**OFFICE OF ENVIRONMENTAL  
SUSTAINABILITY**

**INSPECTOR'S REPORT ON AN APPLICATION  
FOR A CERTIFICATE OF AUTHORISATION  
FOR A CLOSED LANDFILL**

<b>TO:</b>	Eimear Cotter, Director
<b>FROM:</b>	Ewa Babiarczyk, Inspector, Environmental Licensing Programme
<b>DATE:</b>	4 <sup>th</sup> May 2021
<b>RE:</b>	Application by <b>Kildare County Council</b> for a Certificate of Authorisation for a closed landfill at <b>Greenhills, Athy, County Kildare</b> . Certificate of Authorisation Register Number <b>H0208-01</b> .

**Figure 3: Approximate extent of deposited waste**

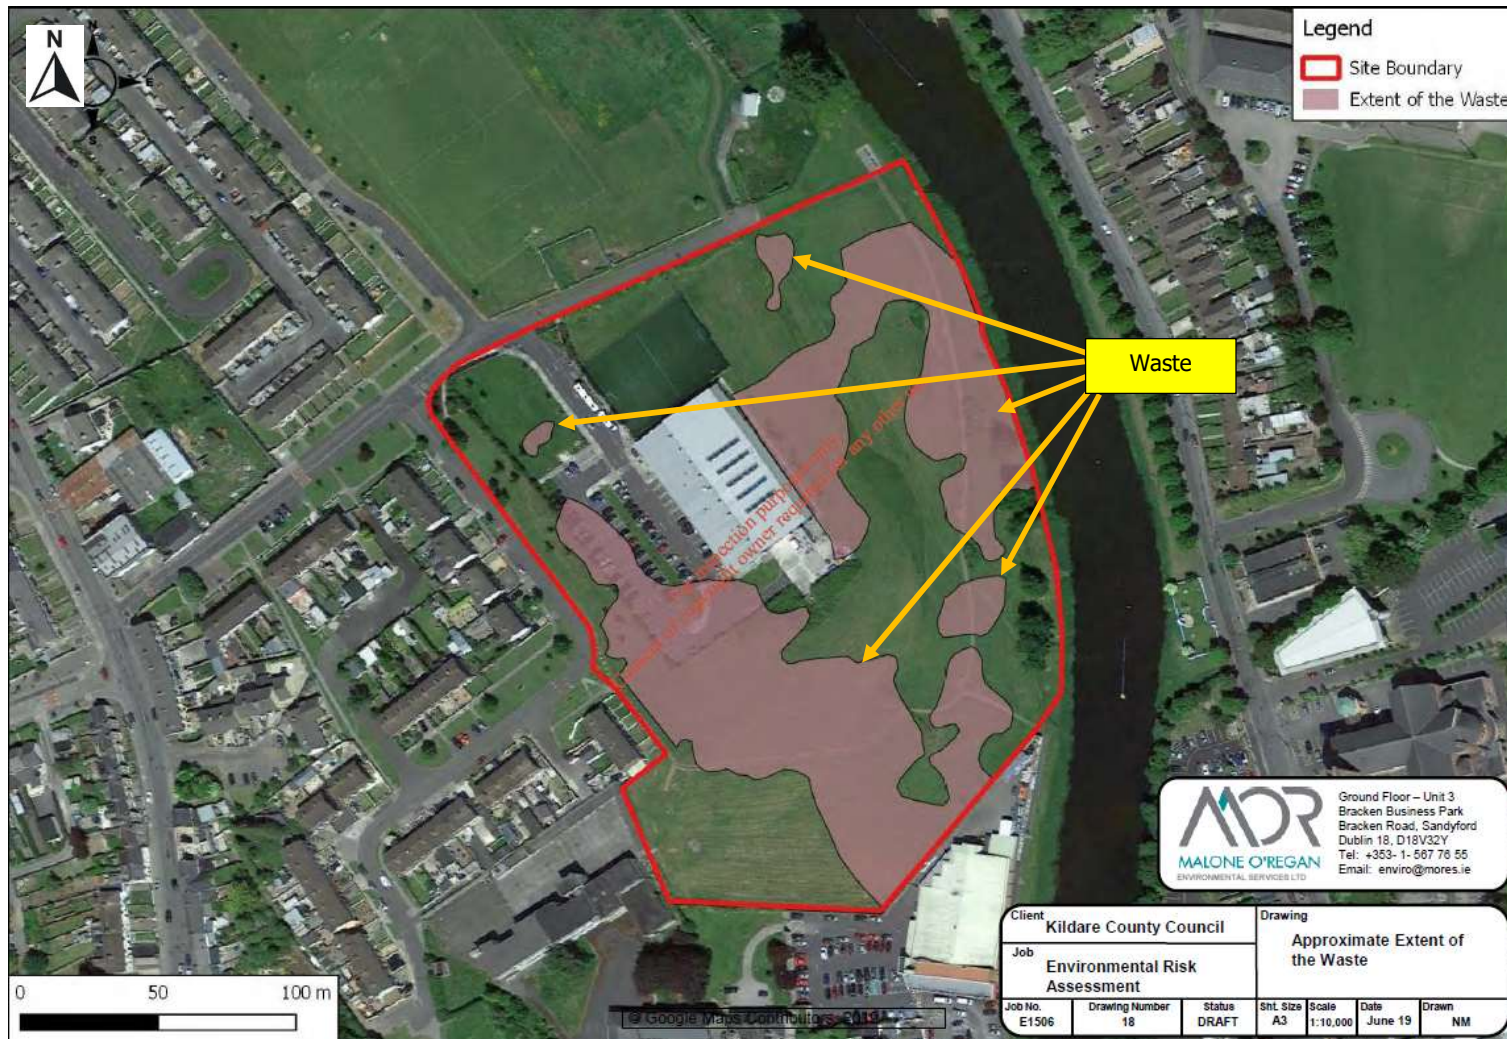
located at the north-eastern corner of the site and the waste was mainly deposited in other parts of the site, as shown in Figure 3. Therefore, it is considered that the monitoring results from GW1 are not fully representative of groundwater conditions downgradient of the site. Accordingly, Condition 3.1(d) requires installation of at least one additional groundwater monitoring well downgradient of the waste body.

Condition 3.7 requires a drawing showing the interpolated extent of the waste body, the areas capped in accordance with Condition 3.1(b) and the gas vents installed in accordance with Condition 3.1(c).

**Figure 6: Groundwater well (GW), trial pit (TP) and leachate (L) monitoring locations**

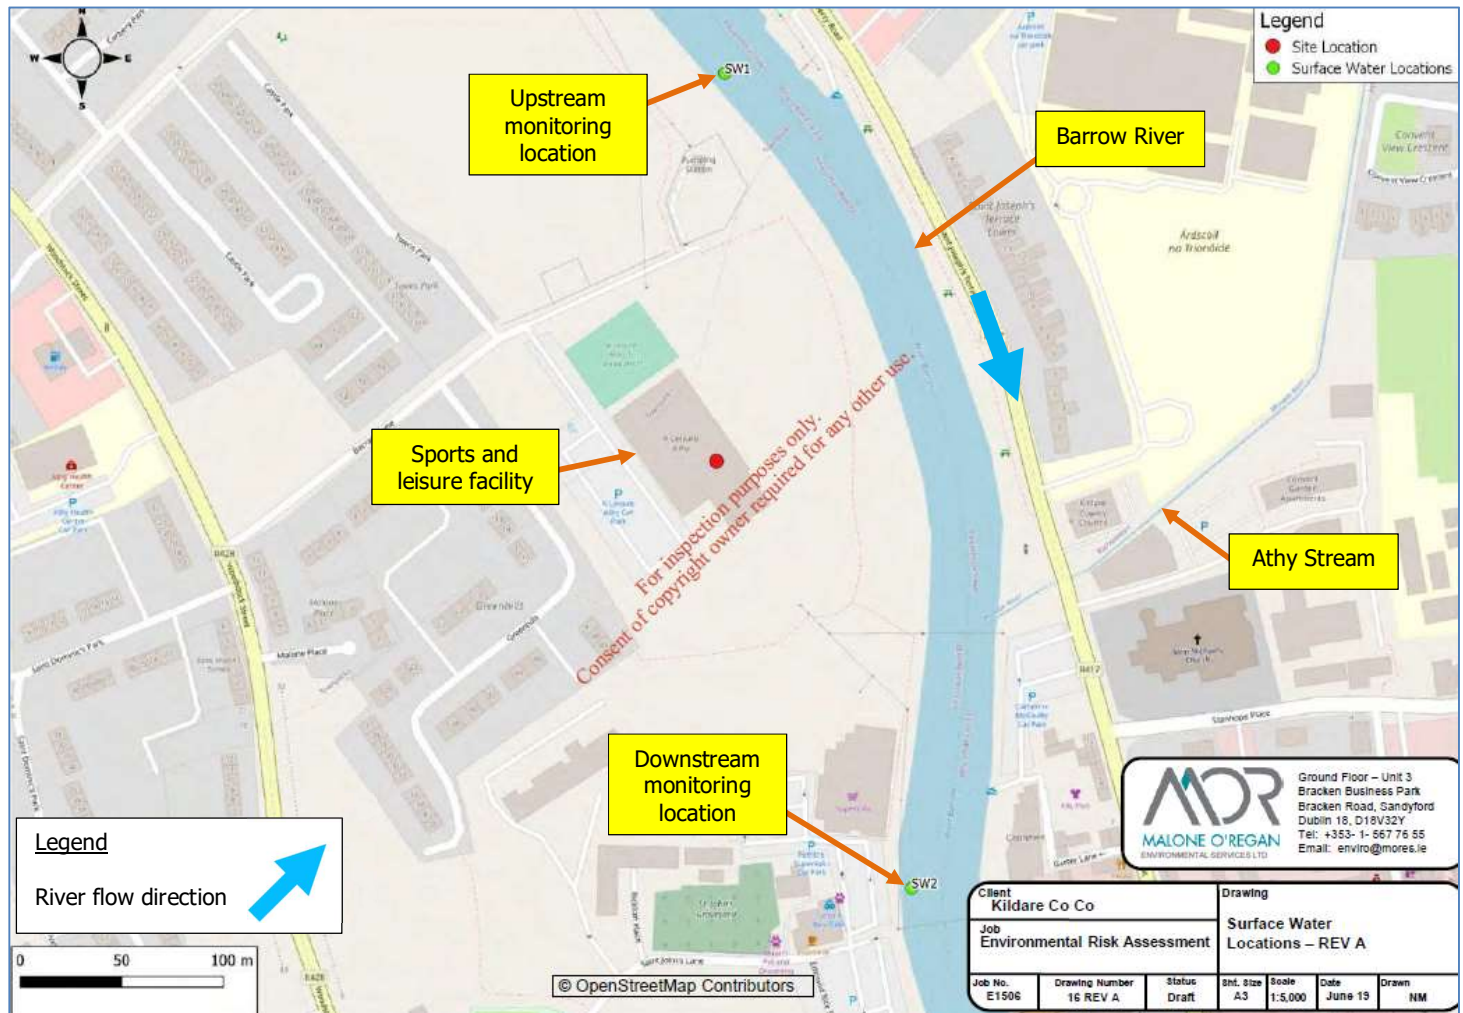
Groundwater monitoring was carried out at three groundwater monitoring wells GW1, GW2 and GW3, as shown in Figure 6, on 23<sup>rd</sup> April 2019 and 8<sup>th</sup> May 2019.

Considering that groundwater flows towards east/ north-east, it is noted that only one of the monitoring wells (GW1) is located downgradient of the waste body. It is noted however, that GW1 is

<p>Condition 3.8(e) requires monitoring on a quarterly basis of groundwater from the existing wells and at least one additional groundwater monitoring well, which shall be downgradient of the waste body. Also, Condition 3.8(f) requires that the sensitivity of the monitoring methods utilised shall have an appropriate limit of detection to allow for comparison of pollutant concentrations against the relevant trigger levels and/or standard reference values.</p>																												
<p>Landfill gas:</p>	<p>There is a risk of landfill gas migration to on-site and off-site buildings. The most likely pathway for the migration of the landfill gas is through the underlying bedrock and existing landfill cover material.</p> <p>Gas monitoring was carried out on 23<sup>rd</sup> April 2019, 25<sup>th</sup> April 2019, 8<sup>th</sup> May 2019 and 29<sup>th</sup> May 2019. In total six wells L1, L2, L3 and GW1, GW2 and GW3, as shown in Figure 6, were monitored. The monitored parameters were methane (CH<sub>4</sub>), carbon dioxide (CO<sub>2</sub>), oxygen (O<sub>2</sub>), carbon monoxide (CO) and hydrogen sulphide (H<sub>2</sub>S). Also, gas flow rate was measured.</p> <p>The below table shows the maximum concentrations of methane and carbon dioxide measured at on-site locations shown in Figure 6. For ease of reading, the monitoring locations outside the waste body are highlighted orange.</p>
